GRADING & DRAINAGE PLAN
FOR DEPENDABLE AUTO SALES

ALBUQUERQUE
BERNALILLO COUNTY
NEW MEXICO

PROPOSED GRADING & DRAINAGE PLAN

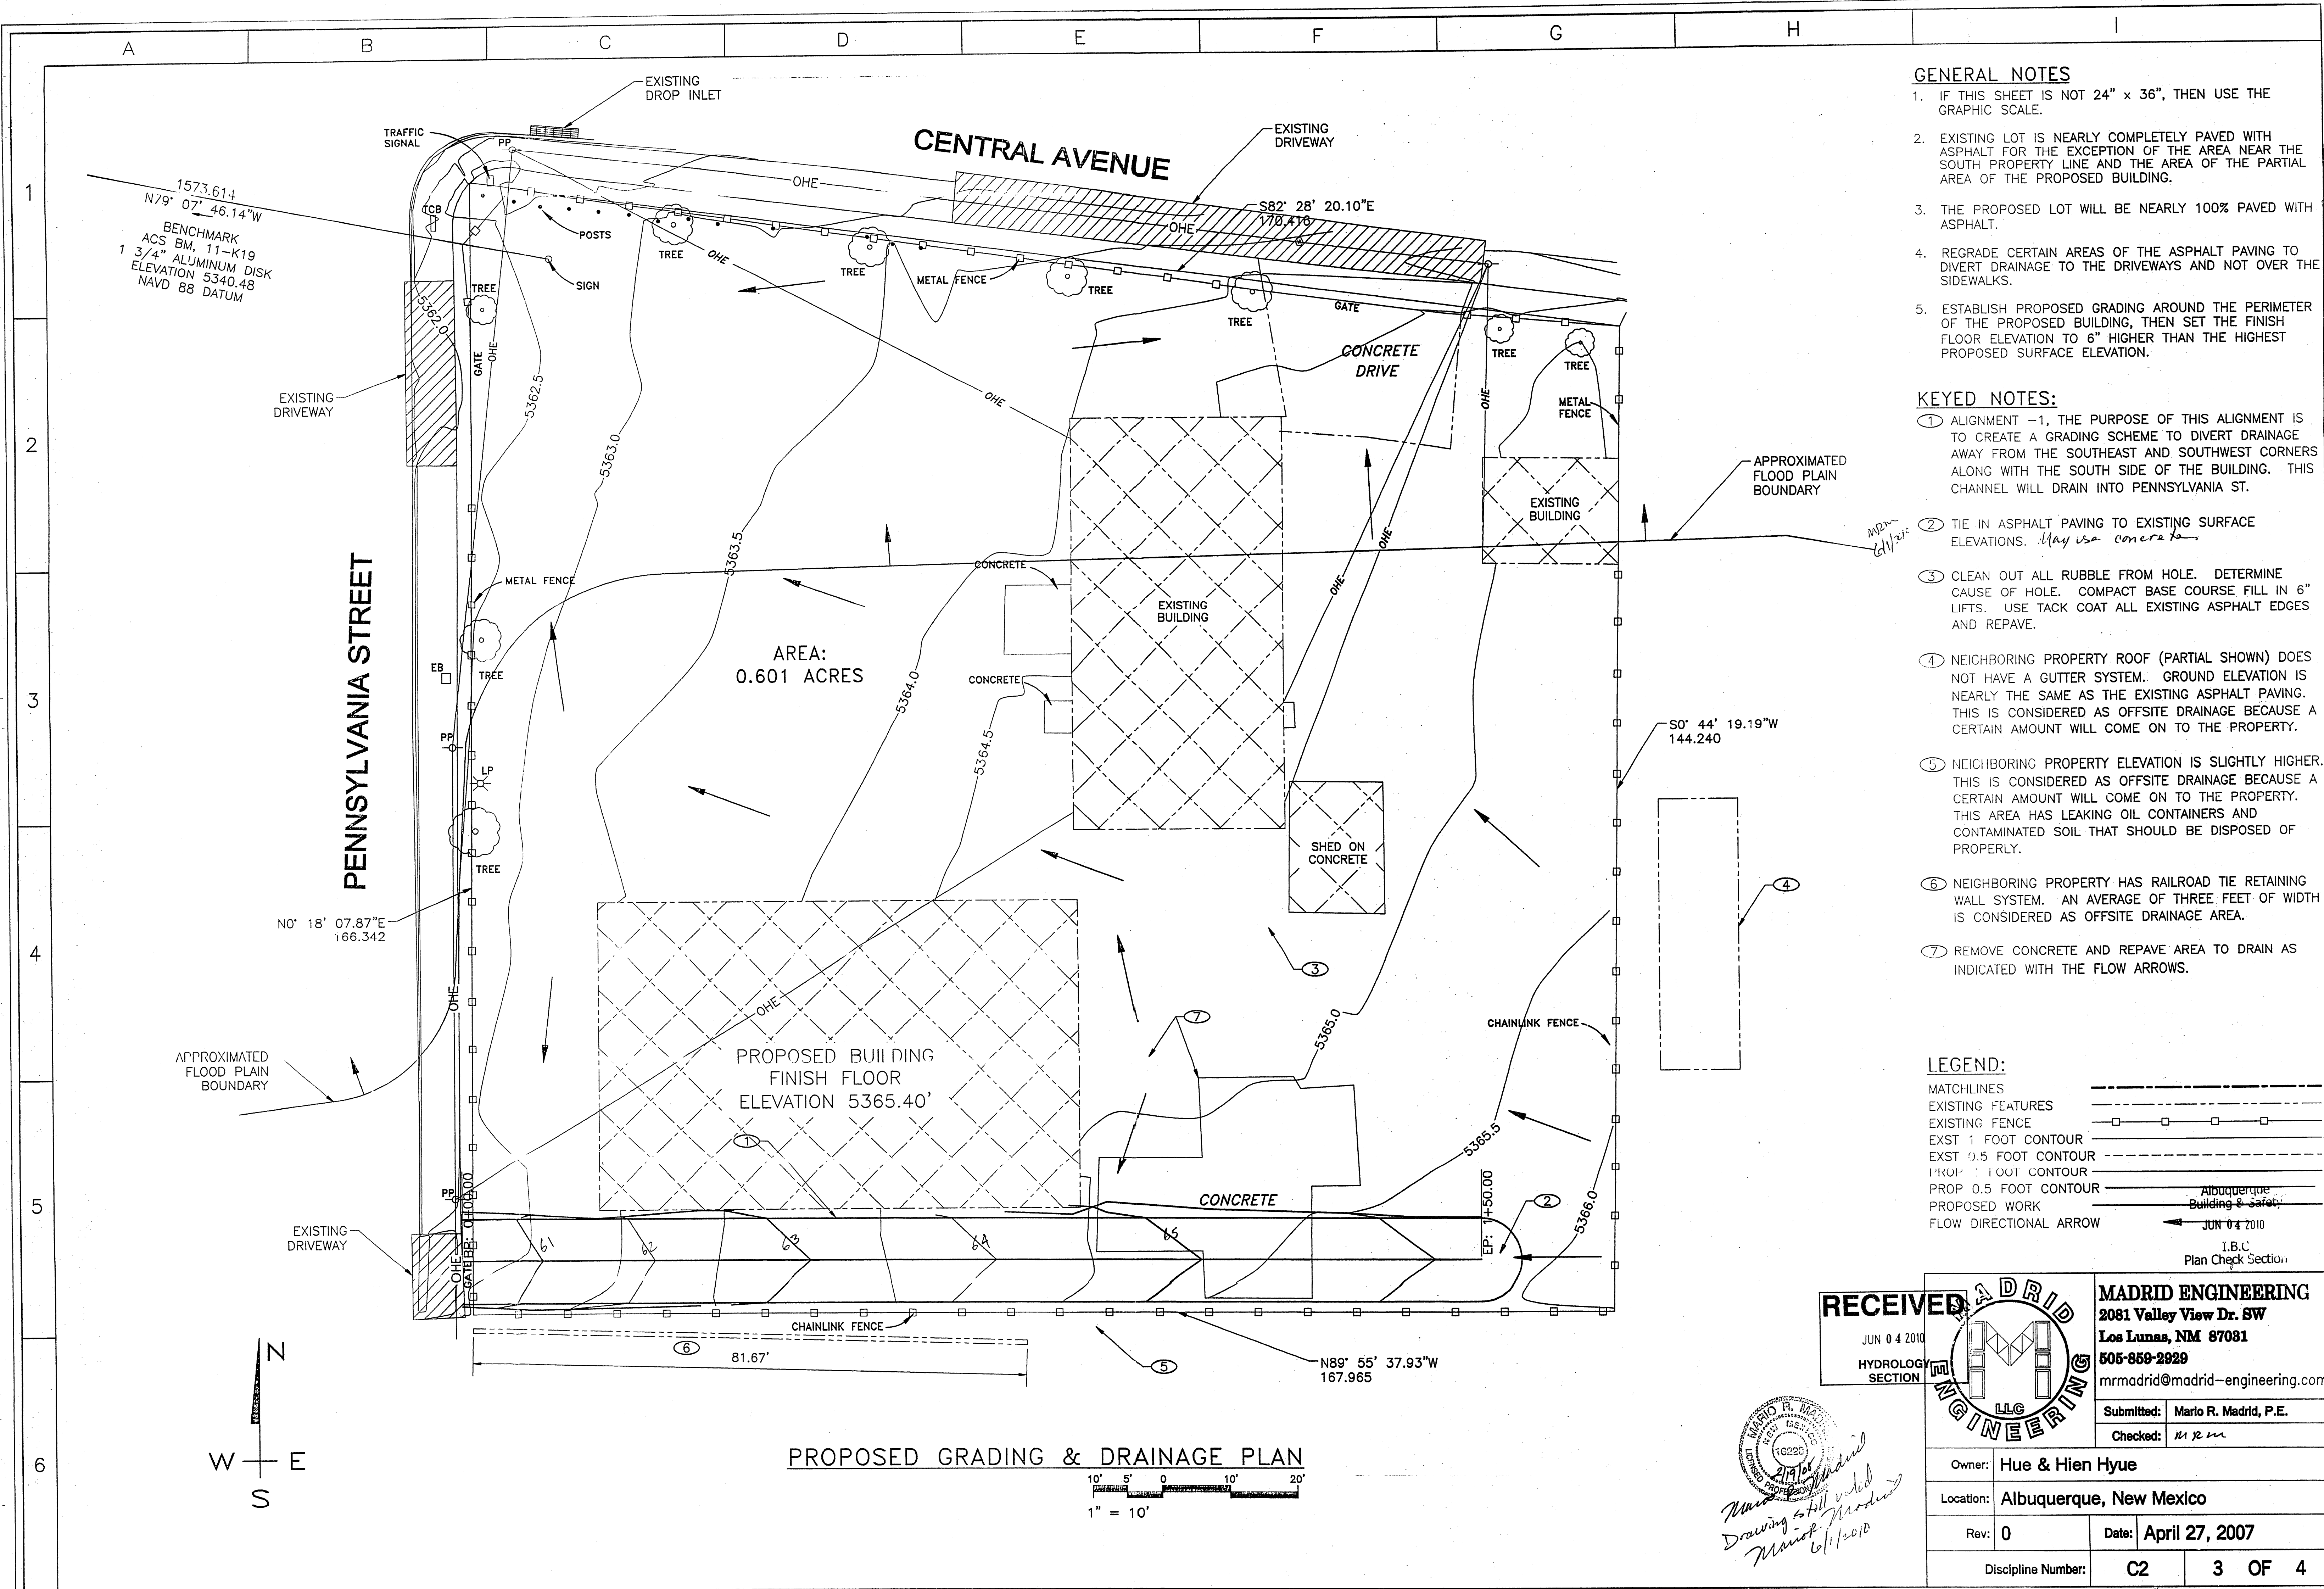
- TIE IN ASPHALT PAVING TO EXISTING SURFACE ELEVATIONS. *May use concrete*
 - CLEAN OUT ALL RUBBLE FROM HOLE. DETERMINE CAUSE OF HOLE. COMPACT BASE COURSE FILL IN 6" LIFTS. USE TACK COAT ALL EXISTING ASPHALT EDGES AND REPAVE.
